1.0 APPLICATION SUMMARY

2.3 Approved Site Plan (partial provided below for size and orientation purposes. See Section 8.1 for full site plan)

2.4 Proposed Site Plan (partial provided below for size and orientation purposes. See Section 8.2 for full site plan)

APPLICATION NUMBER: PRS 21-1041

Figure 2

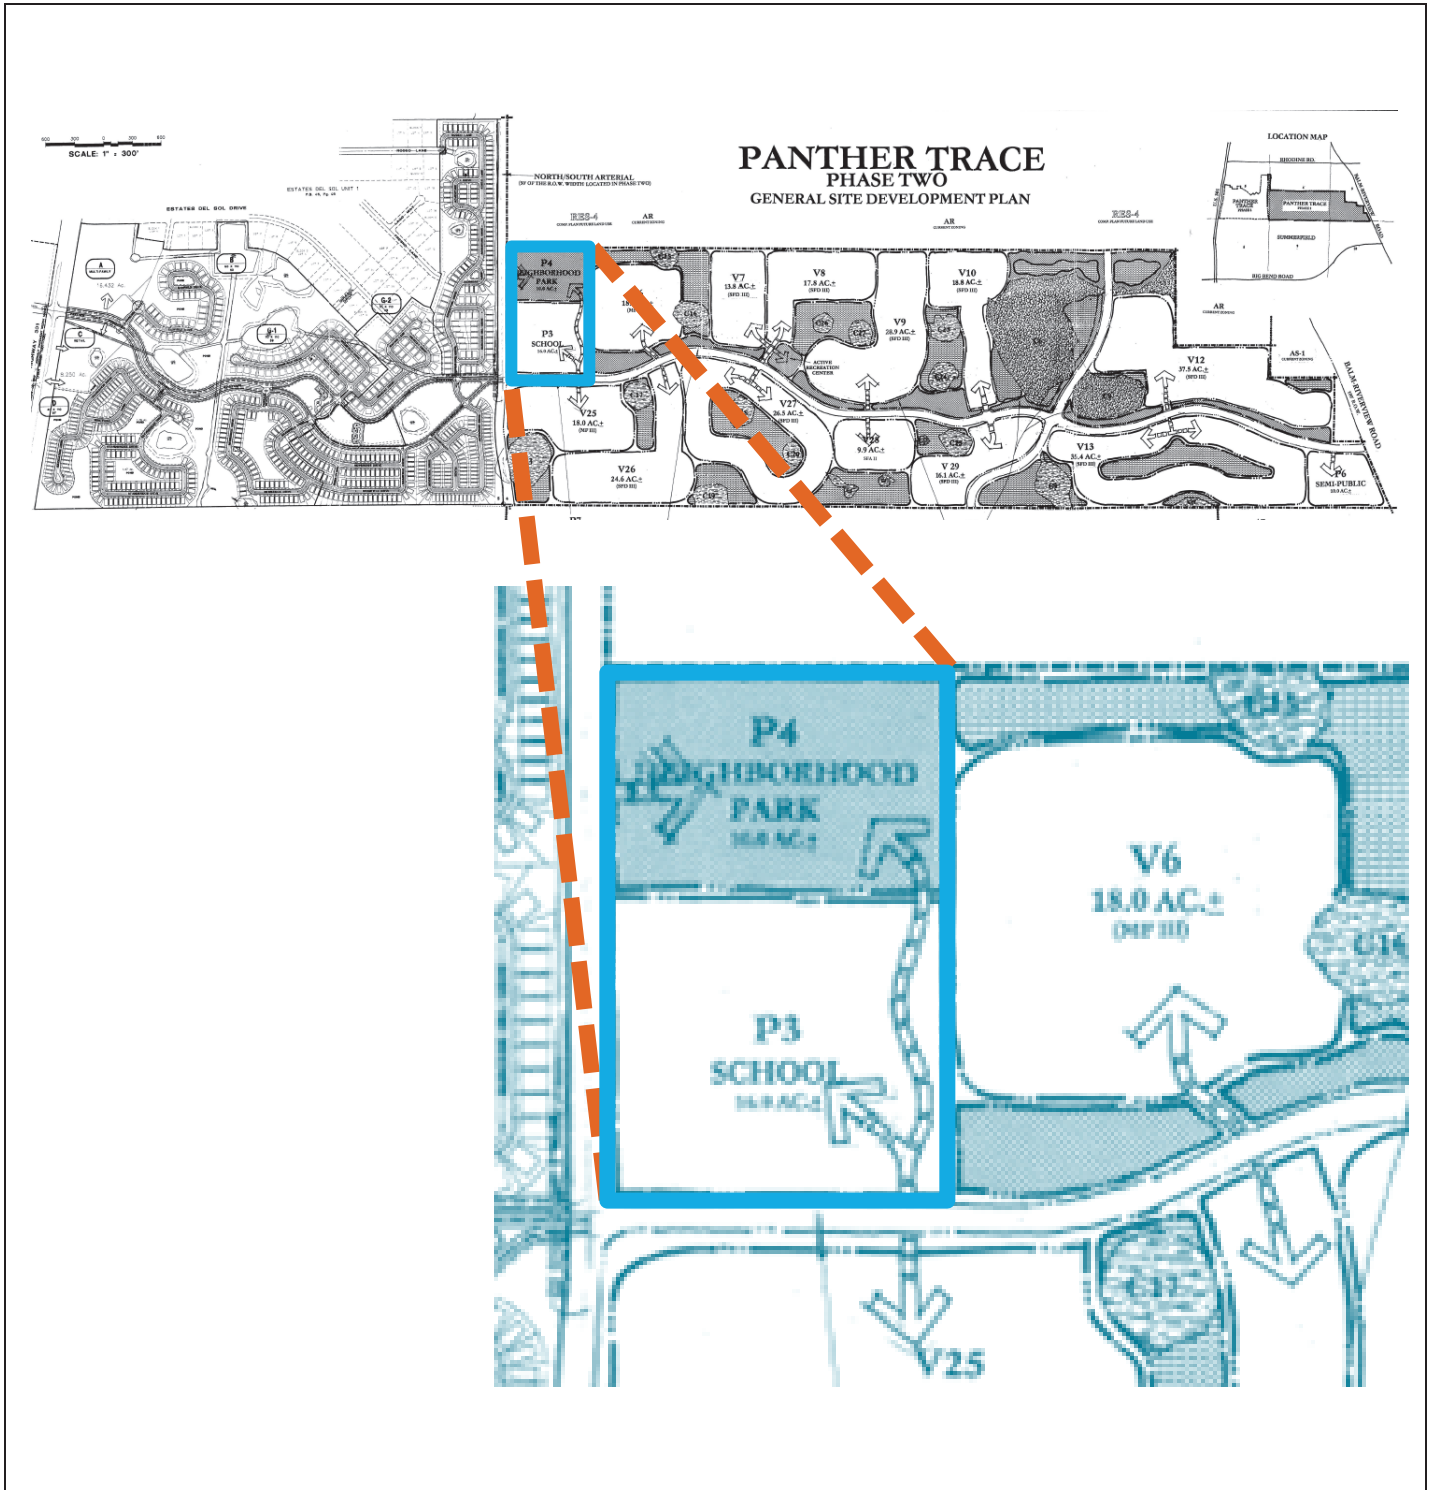
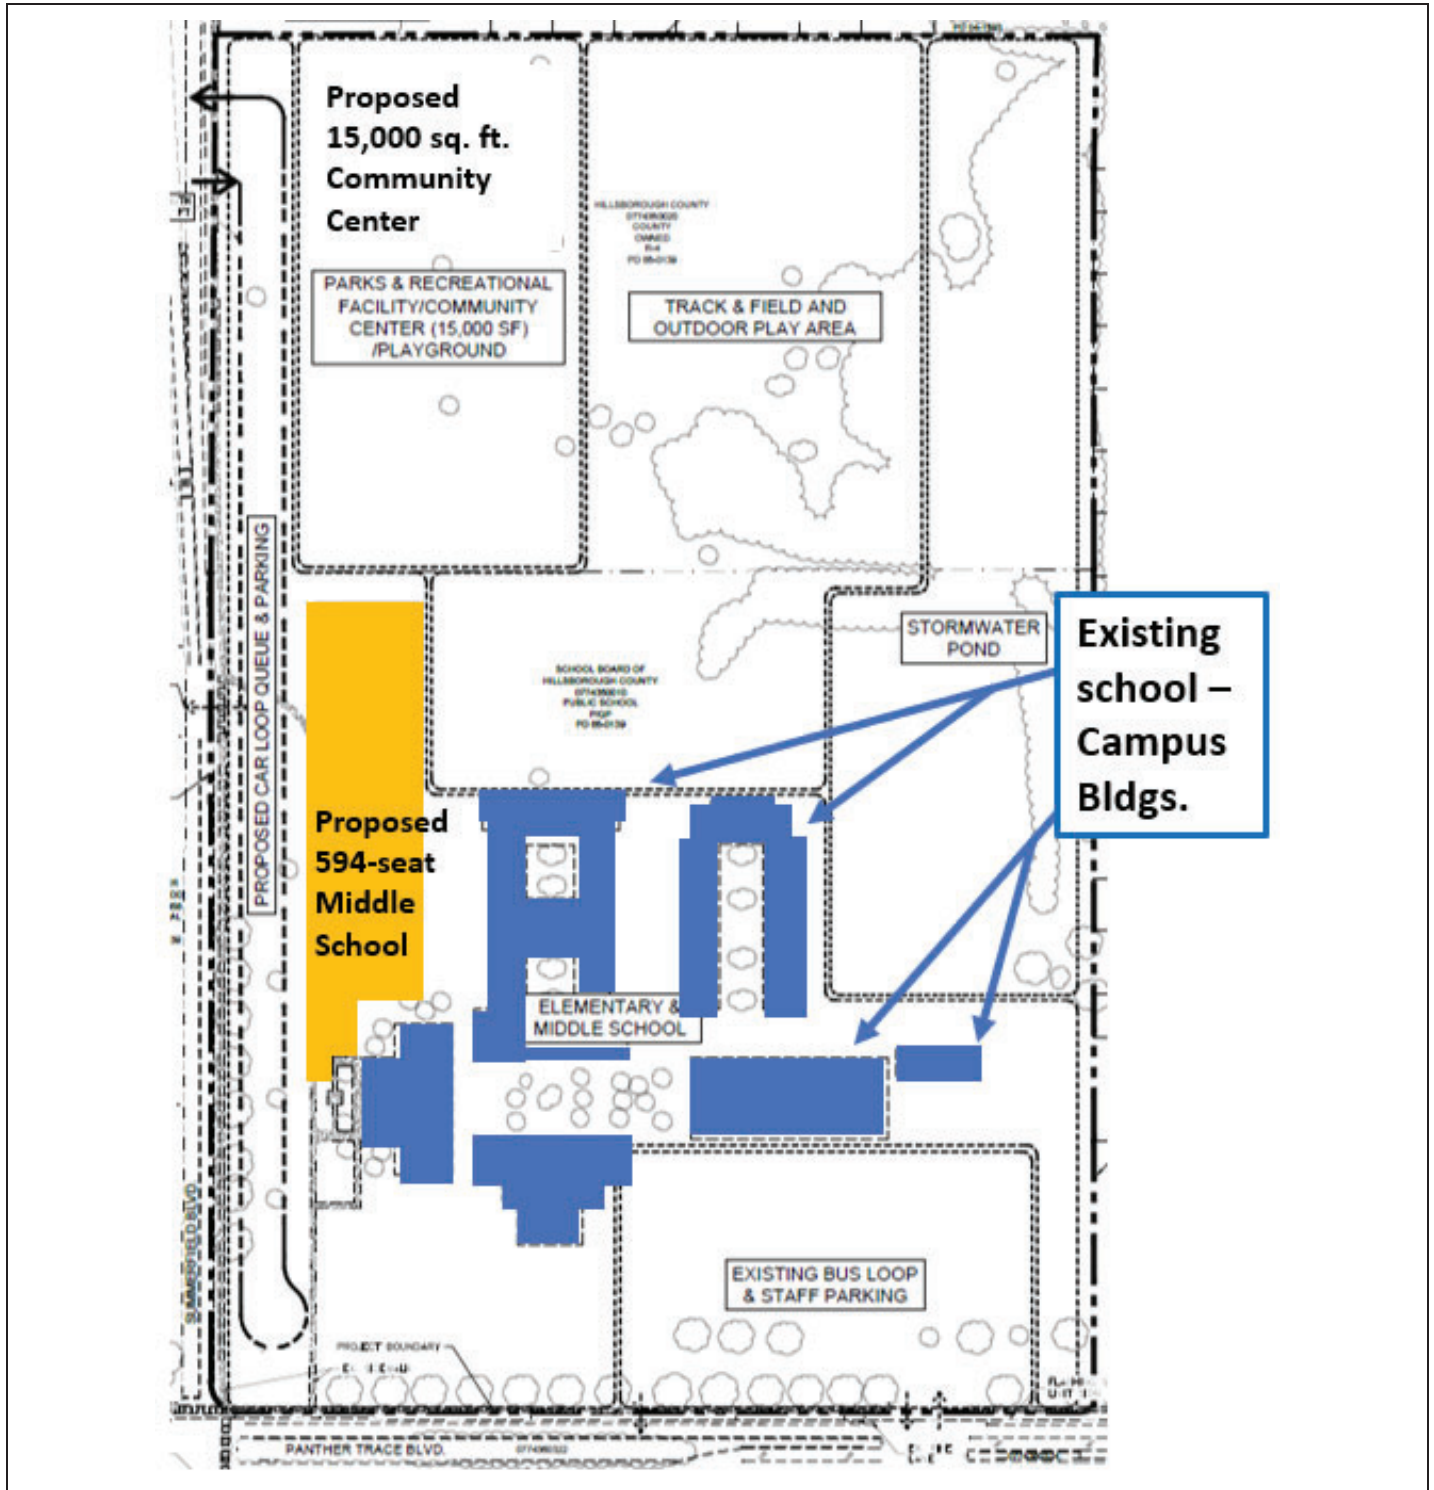
The School Board of Hillsborough County requests to modify condition no. 13 of PRS 20-1307, which allows for “one elementary school.” The applicant proposes to modify the school (Collins Elementary School) by expanding the grade levels from a **K thru 4** elementary school to a **K thru 8** elementary and middle school campus. The applicant also proposes adding a school building along the western portion of the site to accommodate the expanded student population. The area of modification is for the 15.97-acre property approved for the school (“P3 School”) and the 10.16-acre property designated “P4 Neighborhood Park”. The applicant also proposes community use facilities including a track & field, outdoor play area and recreational facility to utilize the neighborhood park for a joint use between the school and public for a total project area encompassing approximately 26.13 total acres.

The request is to construct a single-story, 594-seat addition to the existing 972-seat campus and convert the school from an elementary school to pre-kindergarten through eighth grade school. With this addition, the total student capacity will be 1,566. This expansion will accommodate middle school students. The request also includes the addition of shared park and recreational facilities comprising a 15,000-square-foot community center and recreational facility and an outdoor track & field outdoor play area, located directly north of the school and utilized by the school and public.

13. The developer shall dedicate to the County, upon request of the County usable land for one 15-acre elementary and middle school site. If ever it shall be determined that the school site shall not be used for a school, said action shall be considered a conceptual modification.

8.2 Proposed Site Plan (Full)

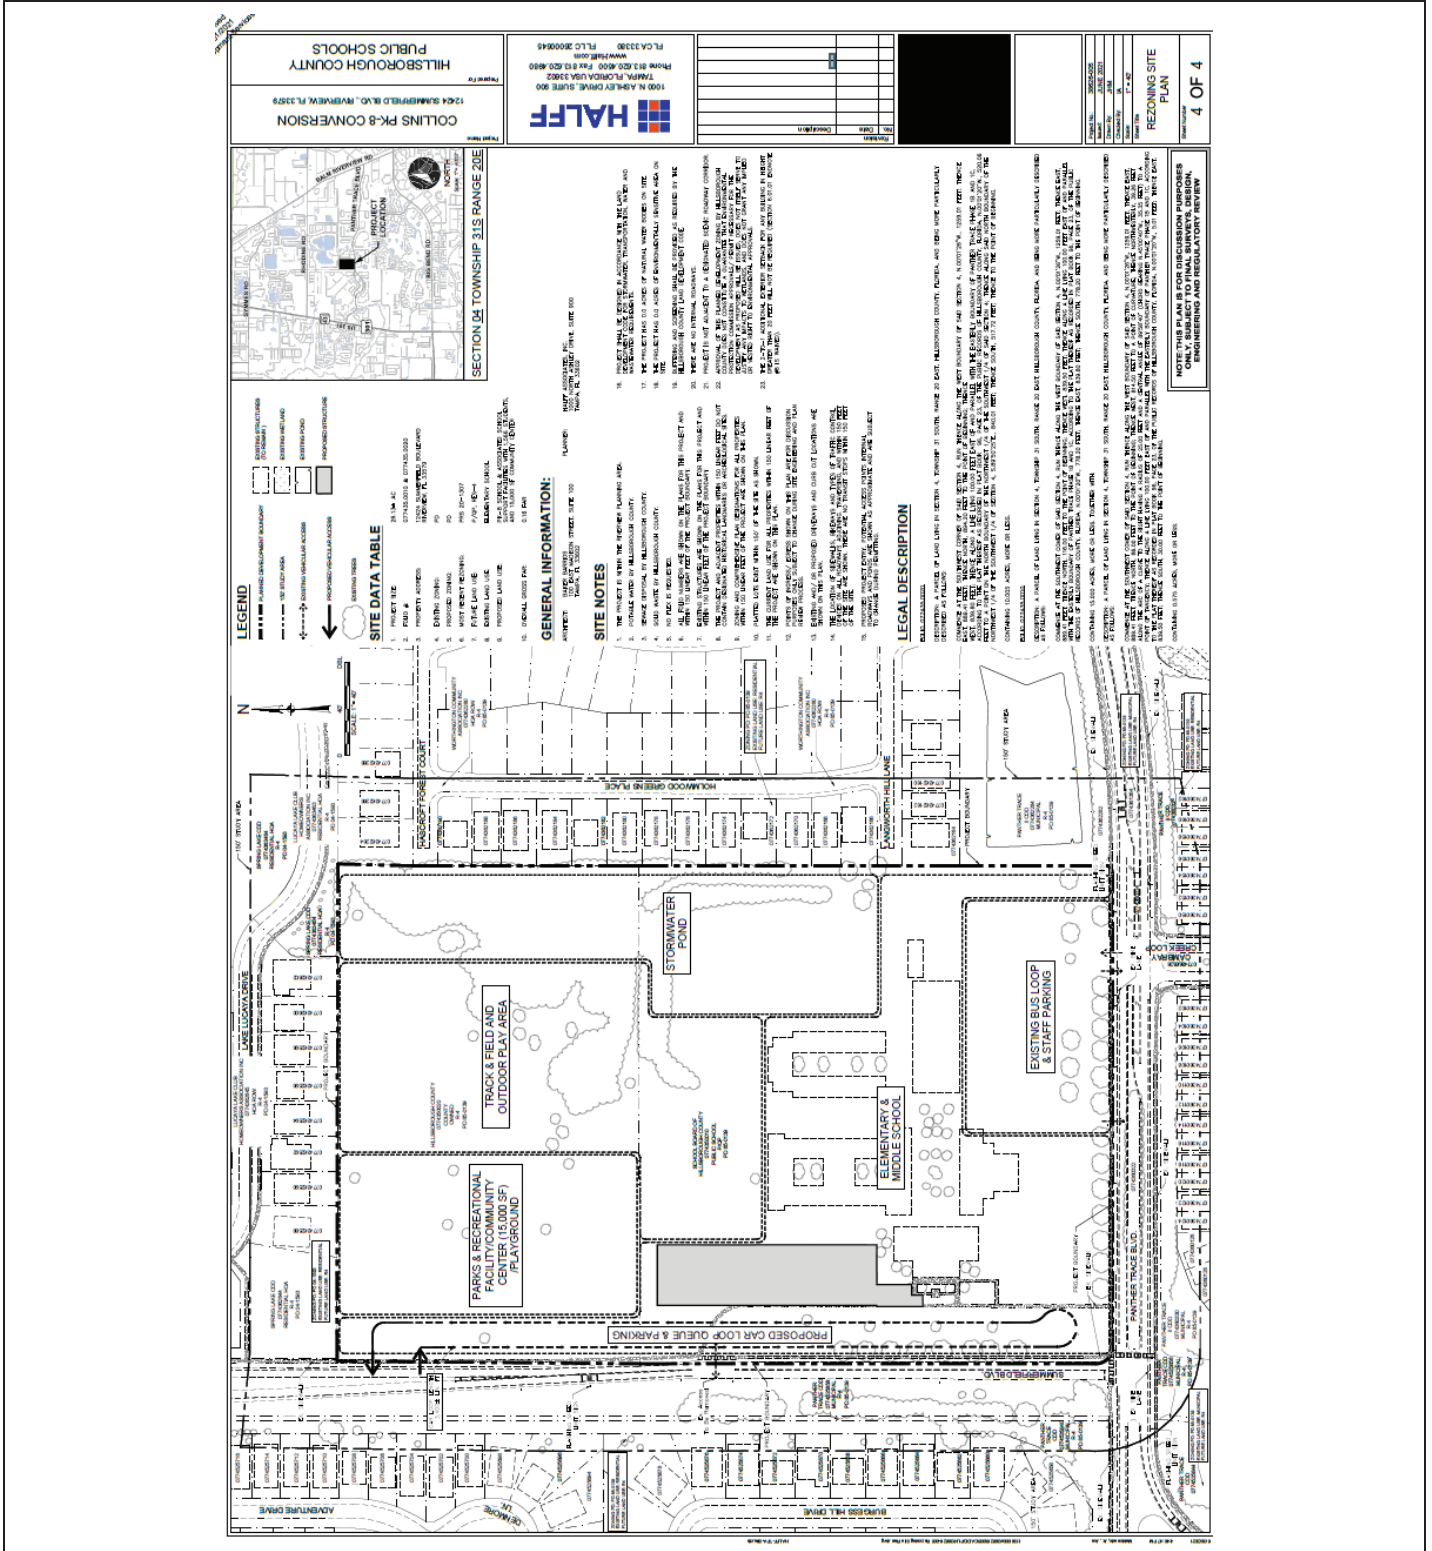
- The site plan depicts wetland impacts that have not been authorized by the Executive Director of the EPC. The wetland impacts are indicated for the construction of a stormwater pond and activity fields. Chapter 1-11, prohibits wetland impacts unless they are necessary for reasonable use of the property. Staff of the EPC recommends that this requirement be taken into account during the earliest stages of site design so that wetland impacts are avoided or minimized to the greatest extent possible. The size, location, and configuration of the wetlands may result in requirements to reduce or reconfigure the improvements depicted on the plan. If you choose to proceed with the wetland impacts depicted on the plan, a separate wetland impact/mitigation proposal and appropriate fees must be submitted to this agency for review.
